Revised Plan Set 11.24.25 Village of Eden Oaks (MPN# 2025-3249) Markup Summary.pdf Markup Summary

BUILDING B SHELL
 INTERSECTION OF MARINA DRIVE, LANDMARK DRIVE & OAK HARBOR BOULEVARD
 PARCEL 14-1 OAK HARBOR
 SECTION 27 & 34, T-9-S R-14-E
 SLIDELL, LOUISIANA 70458
 ST. TAMMANY PARISH
 THIS PROJECT IS NOT FOR OCCUPANCY

**Commercial Plans
 RECEIVED
 11/24/2025
 DEPARTMENT OF
 ENGINEERING**

**ENGINEERING
 REVIEW COPY**

SECTION VIEWS

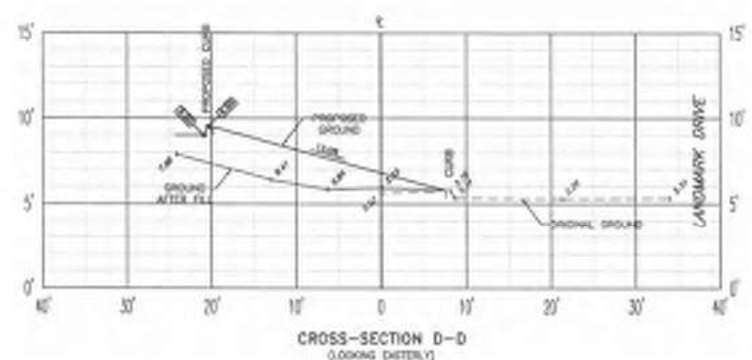
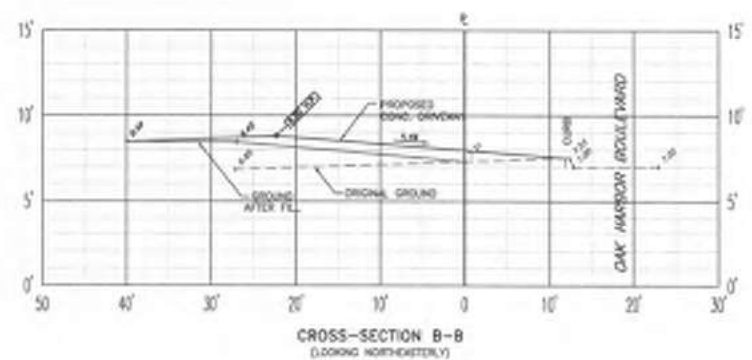
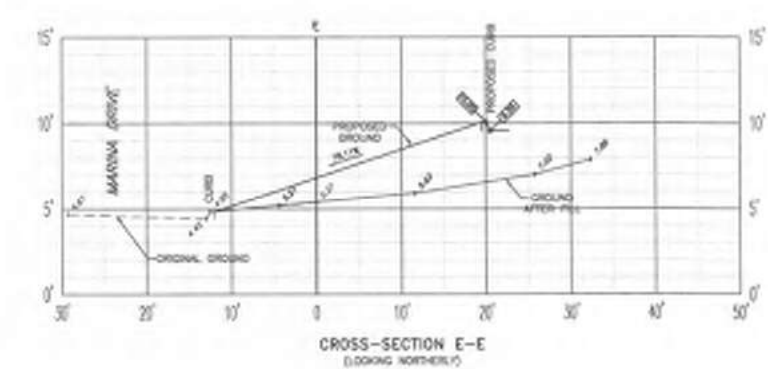
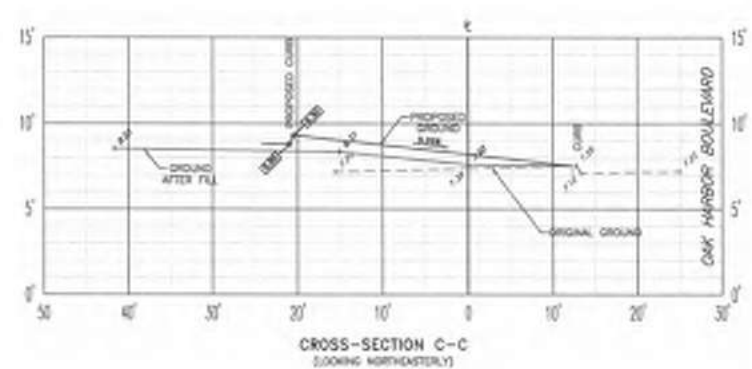
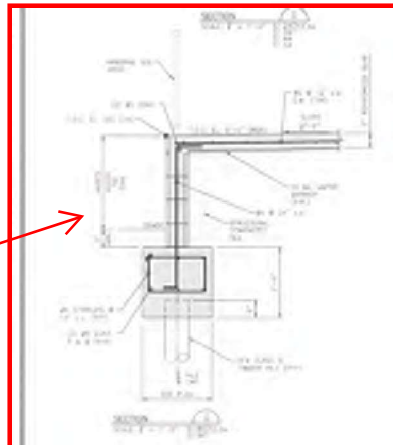
Provide written authorization from utility provider for proposed fill encroaching into utility servitude.

Per the construction detail provided for the retaining wall, only 6" of fill is required on Parcel-W (Side).

Clarify if additional fill is required as shown on Cross-Section A-A or revise accordingly per the foundation plans. (Potentially no fill in utility servitude.)

DRAINAGE & GRADING PLAN

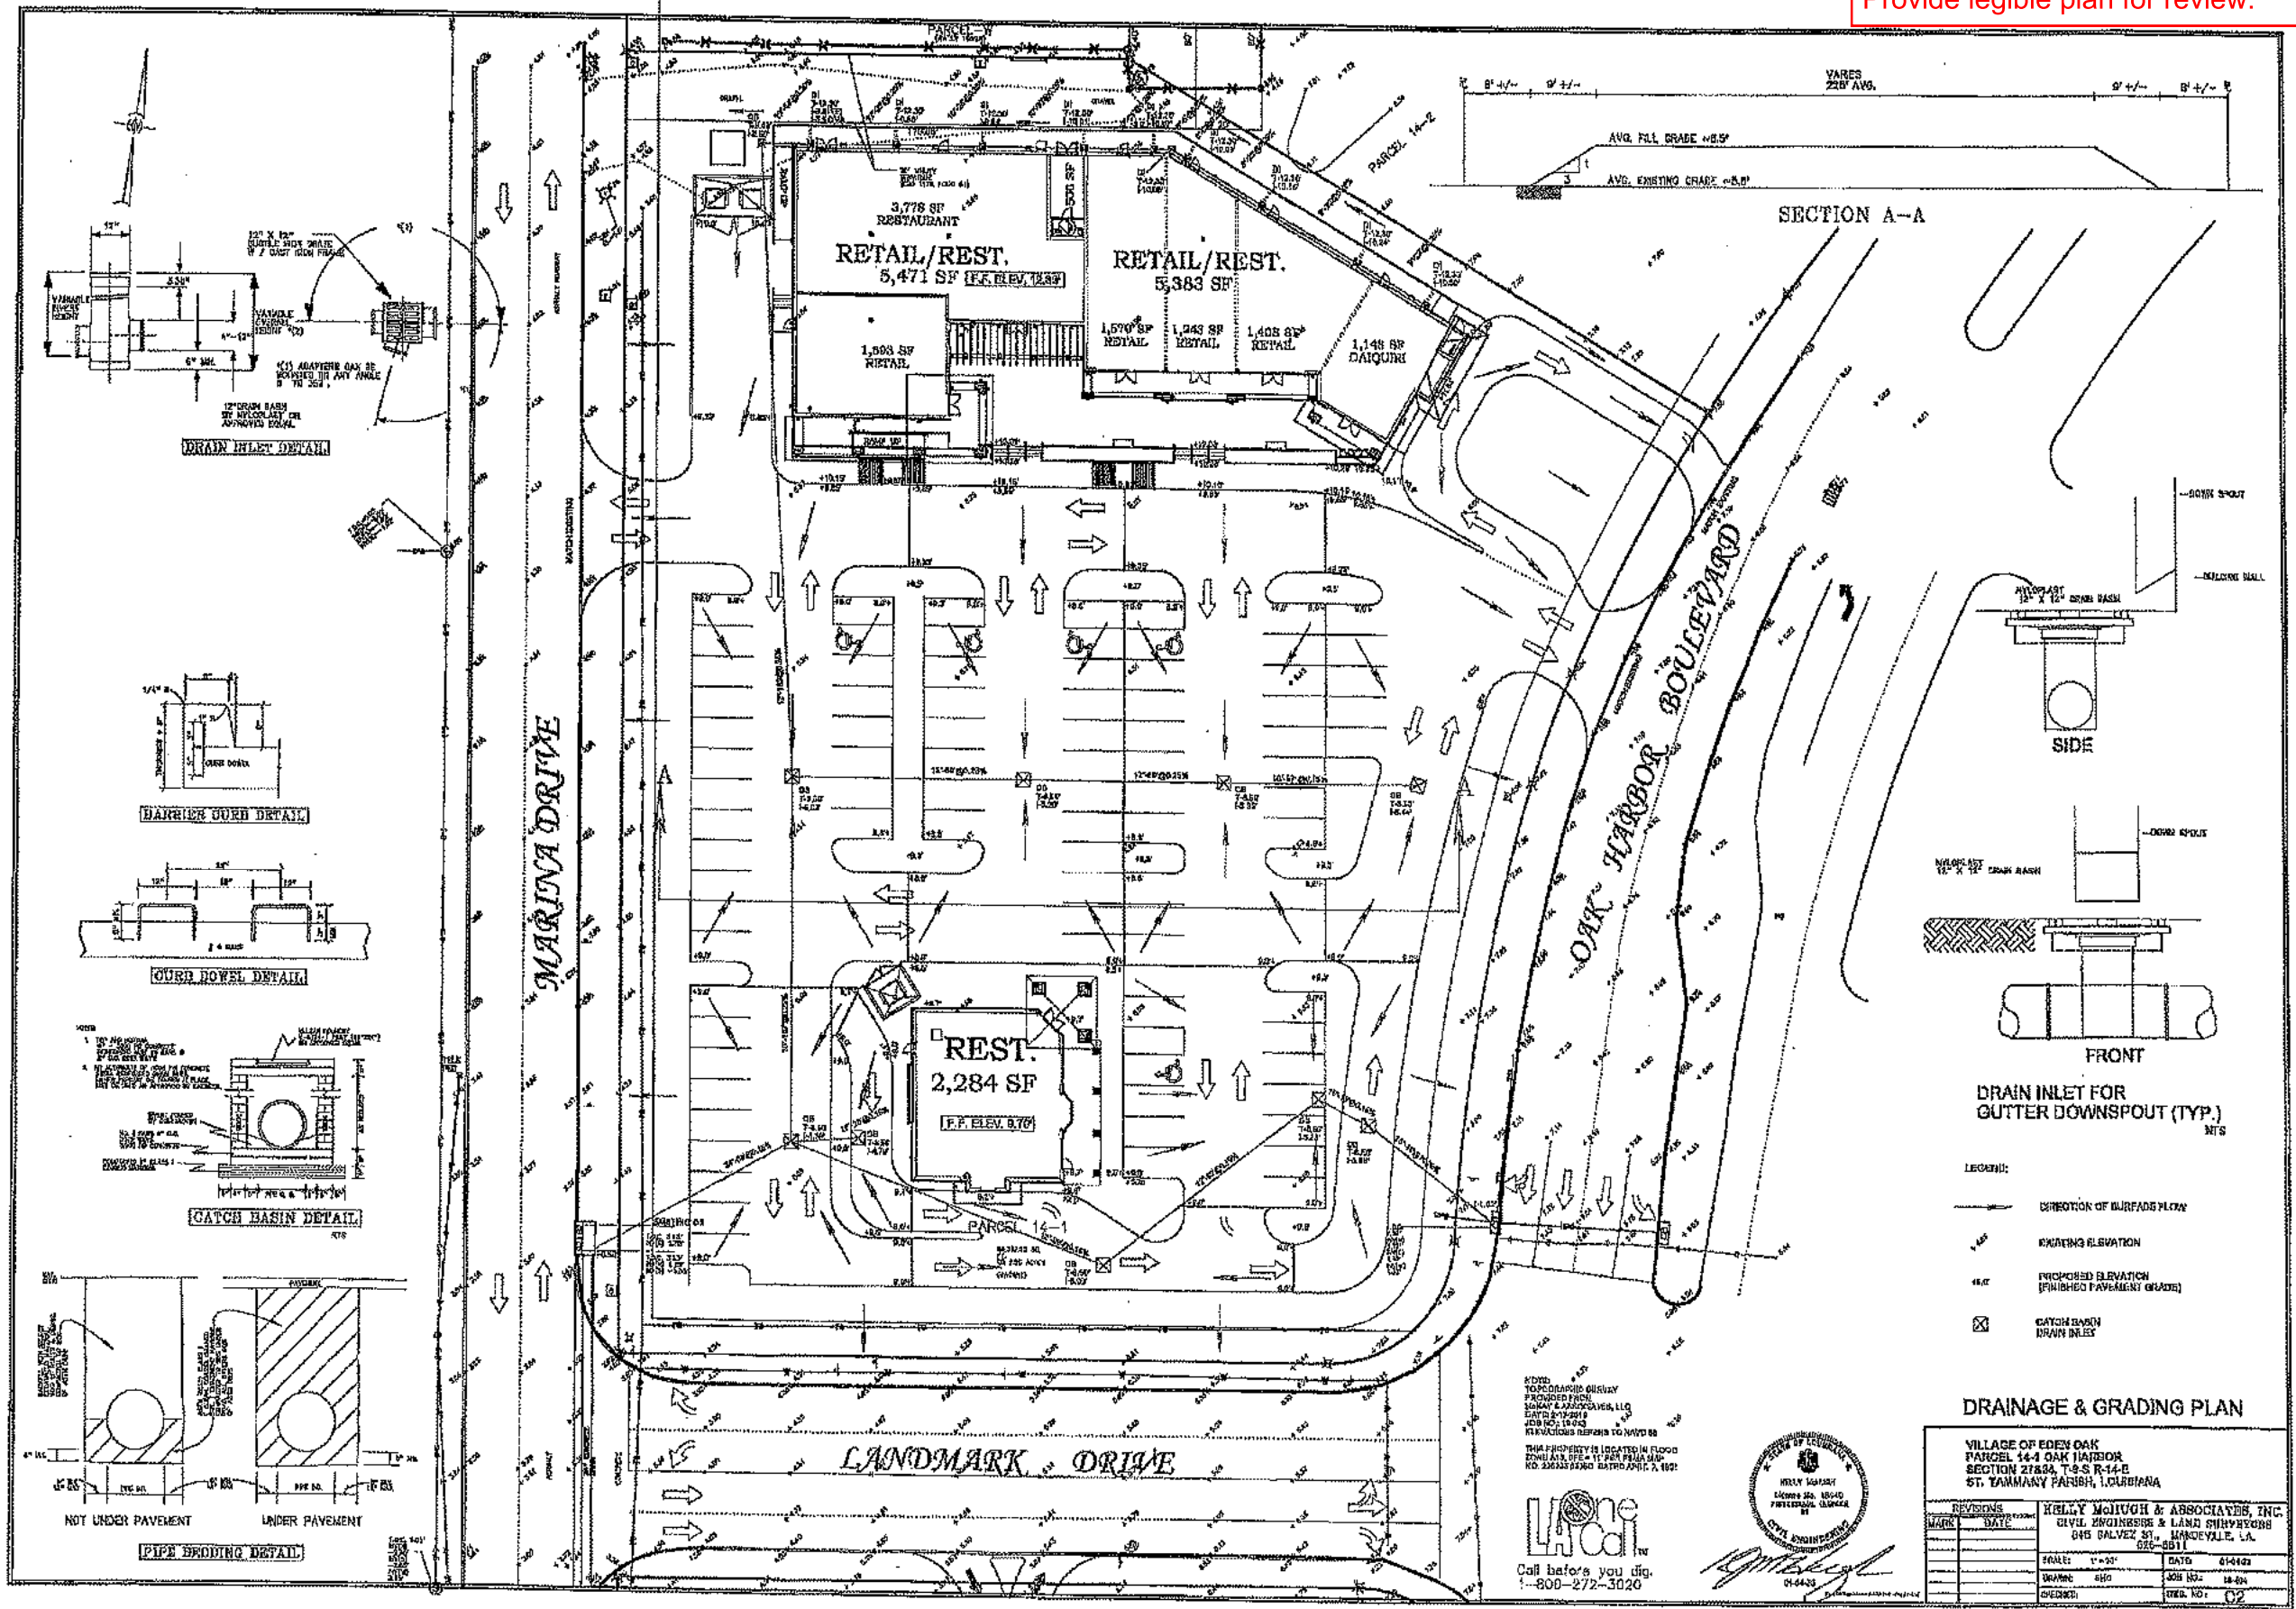
The text and details on this plan are illegible.
Provide legible plan for review.
